PRODUCT INFORMATION SHEET - V8 CYLINDER HEAD GASKETS

UE31004 - UT12890PD - 07V103147

TSD4446 - SZ/E11 - Page 1 of 3

CYLINDER HEAD GASKETS

Images show examples of both internal and external leaks.

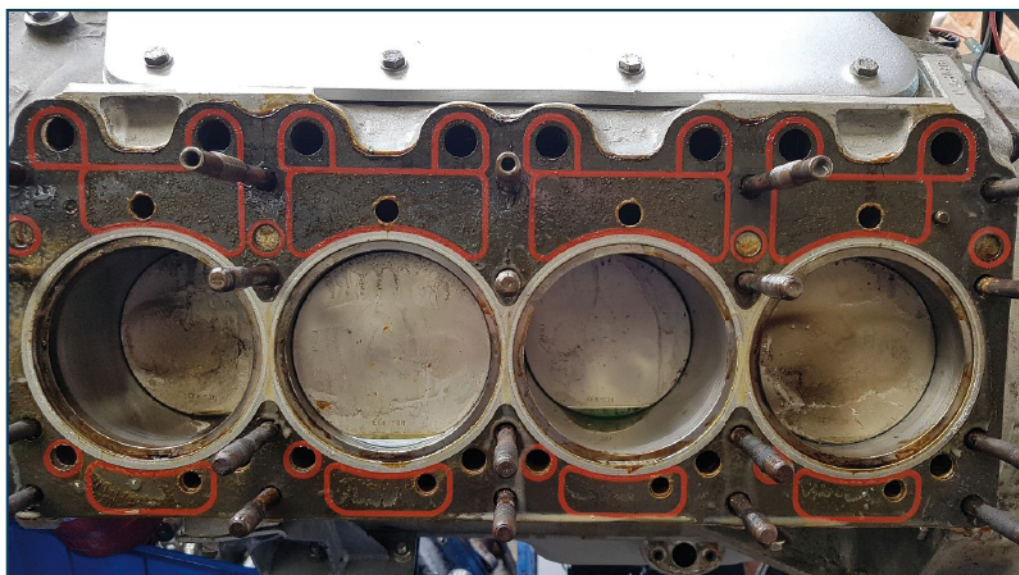
Since March 2019 we have become aware that some engines, having had the head gaskets replaced, have leaked externally and/or internally. We believe that it is the head gasket itself that is the cause of these failures. As part of our investigations into these failures we have been measuring batches of gaskets and recording the dimensions. This has led us to conclude that the most likely cause of the gasket failure is that the difference in height between the steel firing ring (the section around the top of the cylinder liner) and the composite material (that forms the principal part of the gasket) exceeds acceptable tolerances. Allied to this is a suspicion that the red silicone beading has not been correctly applied to the gasket.

We have regrettably removed these gaskets from sale as we are unable to offer any warranty on them.

Fig 3 New Gasket Now Used on
ALL Engines (UE 45215)
A One hole has been deleted
B Push rod hole decreased
in size

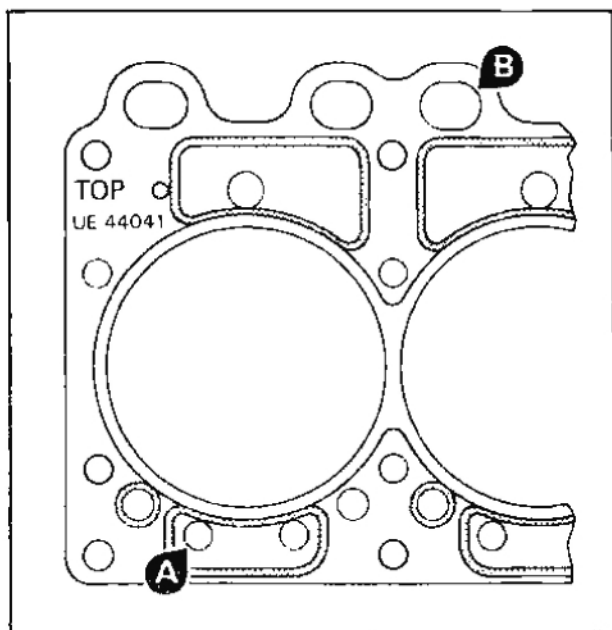
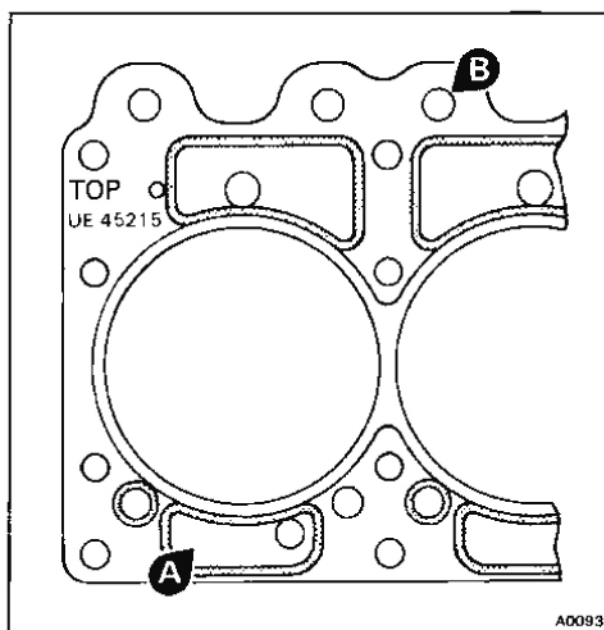
The new cylinder head gasket is similar to that used previously on the Bentley Mulsanne Turbo engine. However, changes have been made to the push rod hole size and one of the coolant hole passages has been deleted (see figs.1 and 3).

The latest gasket (UE 45215) can be used for ALL Bentley Mulsanne Turbo engines, but MUST NOT be used on normally aspirated engines prior to vehicle identification numbers listed above. UE 31004 must be used on all these earlier engines.
